PLAT COMMITTEE April 12, 2023

Case Number: 2023-PLT-010

Property Address: 2204 National Avenue (Approximate Address)

Request: Approval of a Subdivision Plat to be known as Replat of Lot 1- Long Item

Plat Detail

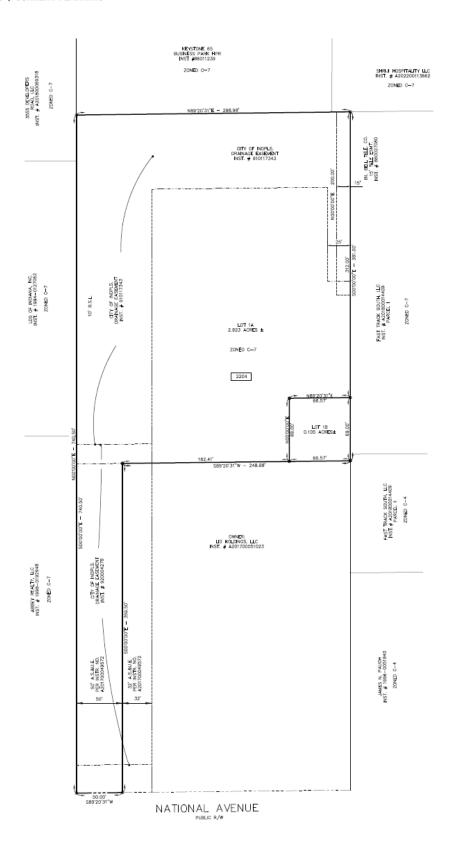
Staff recommends that the Plat Committee **approve** and find that the plat, file-dated February 23, 2023, complies with the standards of the Subdivision regulations, subject to the following conditions:

- 10. That the plat restrictions and covenants, done in accordance with the rezoning commitments, be submitted prior to recording the final plat.
- 11. That all the standards related to secondary plat approval listed in Sections 741-207 and 741-208 of the Consolidated Zoning and Subdivision Ordinance be met prior to recording the final plat.
- 12. That an access easement is provided from Lot 1B to National Avenue prior to recording the final plat.

This site is zoned C-7 and is undeveloped. The proposed plat would subdivide 3.028 acres into two lots: Lot 1A and 1B. Lot 1A would contain 2.923 acres and Lot 1B would contain 0.105 acre. The proposed plat generally meets the standards of the C-7 zoning classification.

Lot 1A would front on National Avenue. Lot 1B would have access to National Avenue via easement. No new streets are proposed as part of this petition.
